L-MT-13-076
10 CFR 50.90

Monticello Nuclear Generating Plant
Docket 50-263
Renewed License No. DPR-22

Monticello Extended Power Uprate: Replacement Steam Dryer – Responses to
Requests for Additional Information (TAC MD9990)

Figure RAI-115-1 Maximum Measured Strain vs. Predicted Strain

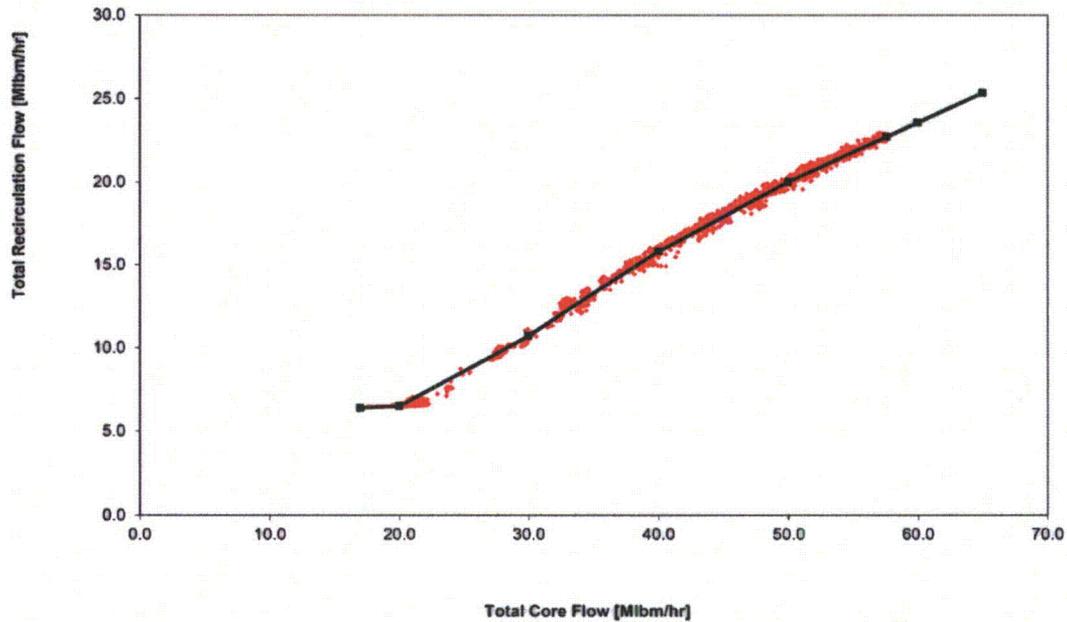
- (a) In Step 5, provide data and plots showing how well the predicted strain magnitudes match the measurement at each gage location.
- (b) Explain Step 6 in more detail. Provide information on the frequency load step. Also, provide a table listing the highest VPF stresses and the corresponding steam dryer component.
- (c) In Step 7, explain how the VPF stress and acoustic stress are combined.
- (d) Evaluate the measurements of the accelerometers at CLTP and other power levels and confirm whether any rocking motion of the steam dryer is present. If significant rocking is observed in the measurements (accelerometers on one side of the dryer out of phase with those on the other side), explain how this type of excitation and response is accounted for in estimating VPF stresses.

(c) At each node in the FEM, the [$J^{a,c}$

Figure RAI-115-3 Power/Flow Map

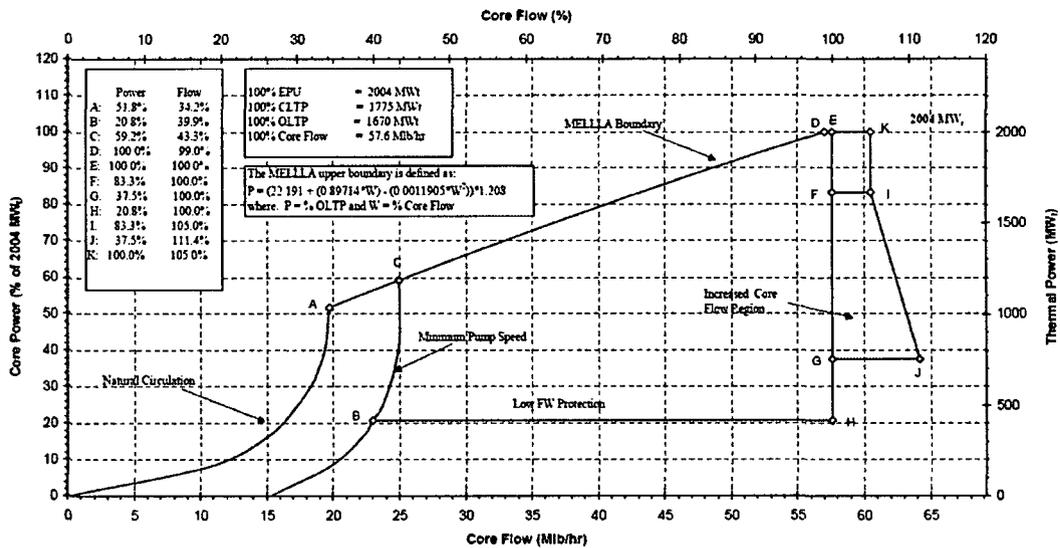
- (e) RCP VPF tonal amplitudes are not expected to increase at EPU conditions.
- (f) whether the previous power ascension calculations span the expected operating conditions of the RCP at EPU conditions?
- (g) Does the RCP pump operating condition (flow rate/rpm) change at EPU? If so, how might this affect the VPF tonal amplitude?
- (h) The staff is waiting for actual RSD stresses at VPF tones to compare to those from acoustic loads.

(f) Figure RAI-115-3 following shows the Power/Flow Map for EPU. This shows the core flow rates that are required in order to achieve higher power levels for the reactor. Use of Figures RAI-115-2 and RAI-115-3 allow a prediction of pump speed ranges required to achieve a specific power level. For a power level of interest all core flows to the right of the MELLLA boundary are acceptable. Power ascension testing at CLTP did include a broad range of pump speeds; see Table RAI-95b-1 in LTR-A&SA-13-14, Revision 0, "Responses to the US NRC Request for Additional Information Relative to the Monticello Replacement Steam Dryer Acoustic/Structural Analyses Set #5" for more information. Pump speeds ranged from 15.0 Hz at 5% power up to 54.1 Hz at full CLTP power.

Section 2.2 of WCAP-17549-P notes that 14 data sets were used between 15% and 100% power to define VPF. This provides a good representation of possible pump speeds. Conservatism is provided by considering that all strain measured in

a VPF frequency is provided by the pump and that the highest measured strain from the 14 data sets that represented the available pump speeds was used to define the VPF load. Since data were available from 15 Hz to 54.1 Hz for pump speed and since the VPF loads were considered conservatively as shown here, the span of expected operation has been considered to define reasonable VPF loads.

(f) Flow rate/rpm will not change significantly and VPF tonal amplitude is not changed, see (e) above.

Figure 109-1, Reactor Dome Pressure Versus Steam Flow

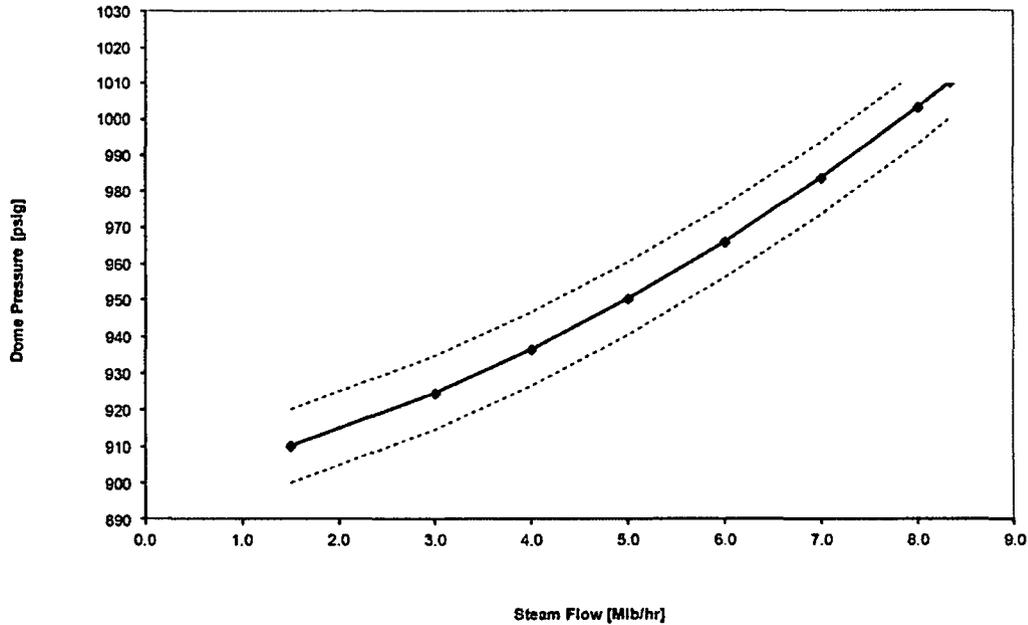
Please provide the expected range of plant static pressures and MSL flow rates at EPU conditions over the remaining life of the MNGP. Explain how you will determine worst-case dryer stresses over this range of conditions and assess the impact of these stresses on fatigue life.

In a telecom on 7/10/13 it was requested to also provide information on how much variation exists in reactor pressure during operation.

Figure 109-1 below shows the expected range of reactor pressure vs MSL flow rate at EPU conditions. Reactor pressure varies based on main steam line differential pressure due to system resistance. The operators establish a turbine inlet pressure

setpoint with the electric pressure regulator at low power and do only minor adjustment to this setpoint as the unit ascends to full power. Turbine inlet pressure controls reactor pressure.

Figure 2: Static Strain Test Rig

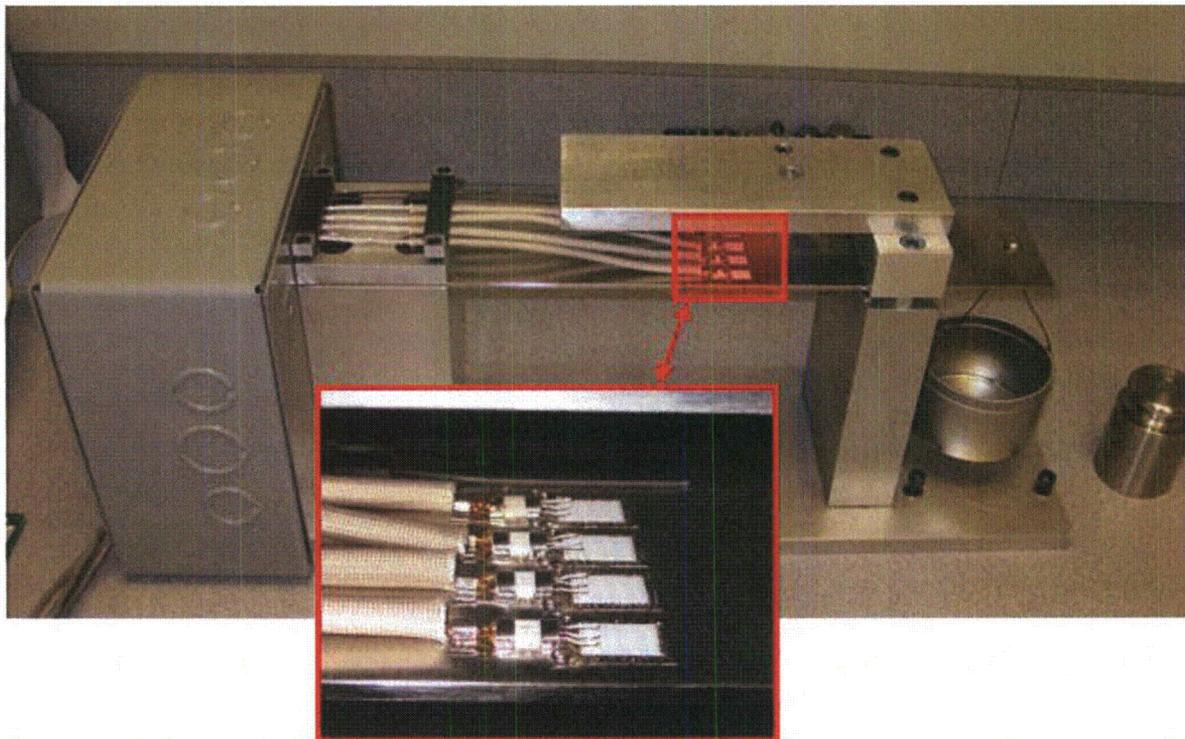
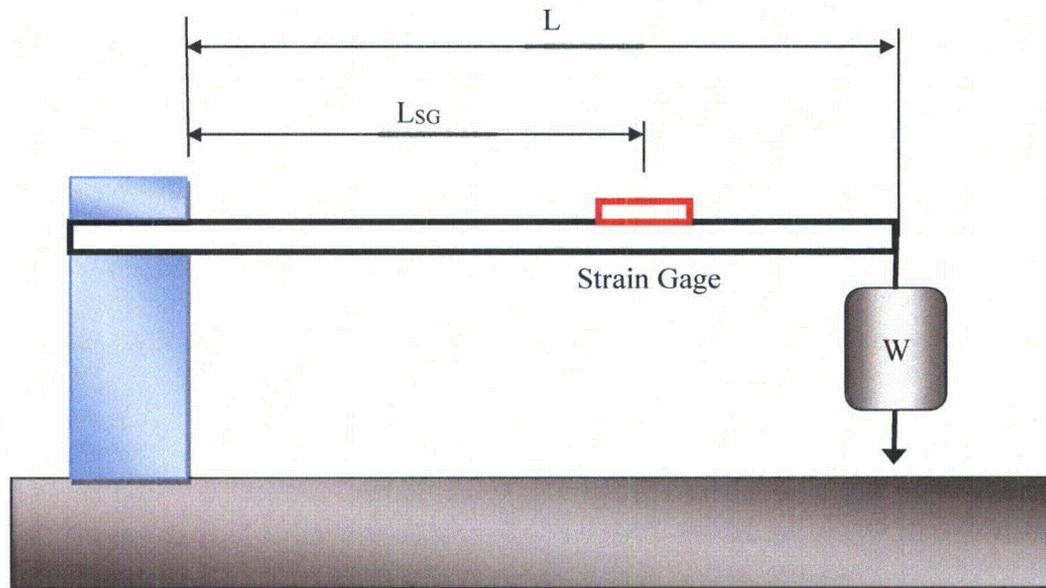
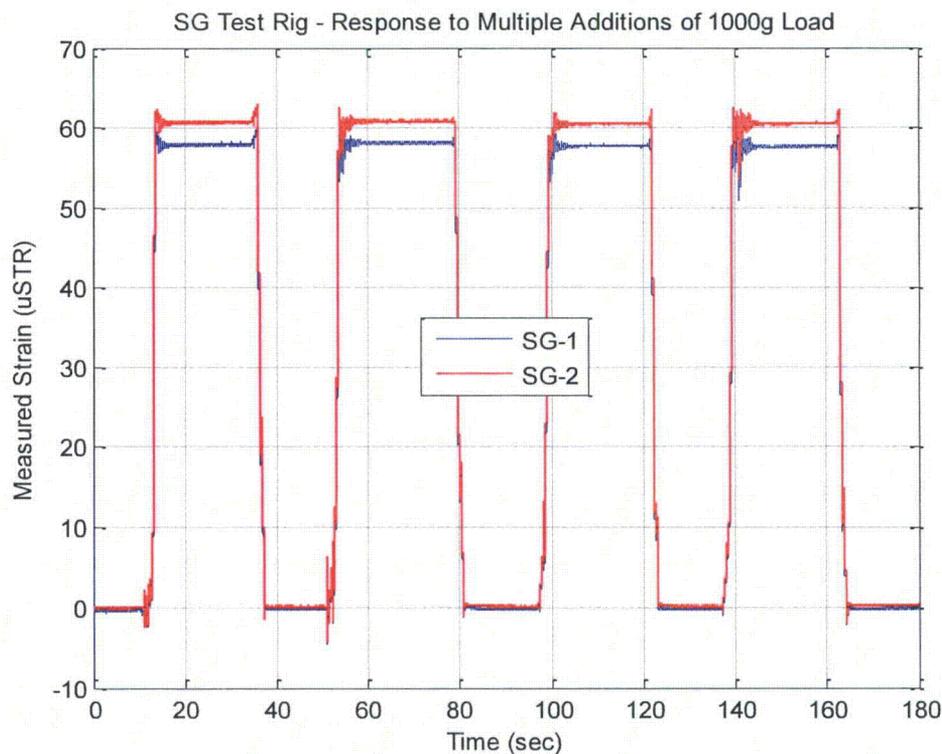
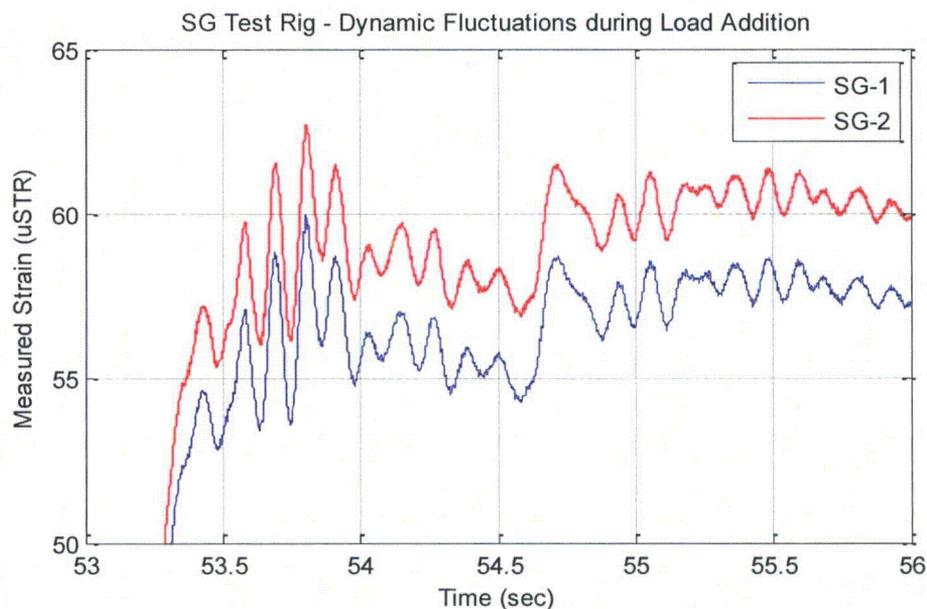
Therefore, while exiting from the current refueling outage at MNGP, the licensee is requested to determine the MSL strain gage under-prediction factor during plant (static) pressurization (comparing with the strain-to-pressure conversion factor currently used by the licensee), and account for any MSL strain gage under-prediction factor in the fluctuating dynamic pressure loading on the steam dryer.

Submit a summary report of the MSL strain gage calibration along with a revised response to MNGP EPU-EMCB-RSD-RAI-68.

Given the hydro pressurization results described above, SIA designed and performed a test to demonstrate the ability of the SGs to accurately measure static and quasi-dynamic strain in a laboratory environment. The test involved mounting four (4) of the HPI SGs in question to a steel plate mounted in a cantilevered fashion. The plate was then deformed by installing a known weight at its unsupported end, and the measurements from the SGs were compared to hand calculations. Figure 2 illustrates the entire test rig, and provides a close-up view of the installed SGs.

For the test rig illustrated in Figure 2 and Figure 3, the beam is nominally 12 in long by 3 in wide, and 1/8 in thick. When measured with a caliper, the width and thickness are 2.9961 in and 0.1138 in, respectively. The SGs are mounted approximately 6-3/8 in from the attachment point. For a 1,000 gram applied load, assuming an elastic modulus of 30×10^6 psi for the stainless steel beam, the calculated strain at the SG location is 63.97 μ in/in.

Figure 4 shows the response of the SGs during several loading cycles. The four (4) SGs on the beam were combined into two (2) WHB channels, and the data was collected using a set of hardware and software that is identical to the DAS at MNGP. The SGs were configured in the

Taking the average of the measured strains ($59.40 \mu\epsilon$), the variation between measured and predicted values is approximately 7.2%. However, there are a number of uncertainties in the test rig setup, any of which could explain all or part of the difference. A list of the uncertainties with potential to influence results is provided below:

Upon closer examination of the response plot in Figure 4, it is evident that application of the load on beam was neither uniform in timing nor instantaneous. The beam vibrates as the load is applied, and the measured response indicates that the accompanying fluctuations self-attenuate over the course of several seconds. Figure 5 provides a graphical representation of this effect.

As shown in Figure 5, the dynamic response measured by the test rig SGs is nearly identical for both SG pairs. The curves are offset slightly due to inaccuracies in the static strain measurements, as described in the list above. For dynamic measurements, the DAS would automatically compensate for this offset during the null balancing procedure that is performed prior to data acquisition. Small variations in WHB signal output would also be identified and addressed via the shunt calibration procedure.

The laboratory test results in Figure 4 indicate excellent correlation between measured and predicted strain over a 180-second data acquisition period (longer than the 120-second typical interval for EPU measurements). The response does indicate some variation (approximately 4.5%) between multiple SGs installed at the same location. That disparity is likely due to a combination of error sources, including wiring configuration, minute variations in SG properties, and installation inconsistencies. However, as demonstrated by Figure 5, the pseudo-dynamic response immediately following load application is extremely similar between channels. That plot provides a good example of the difference between static and dynamic measurements – for a dynamic test, the DAS would have removed any static offset, and the curves would lie on top of one another.
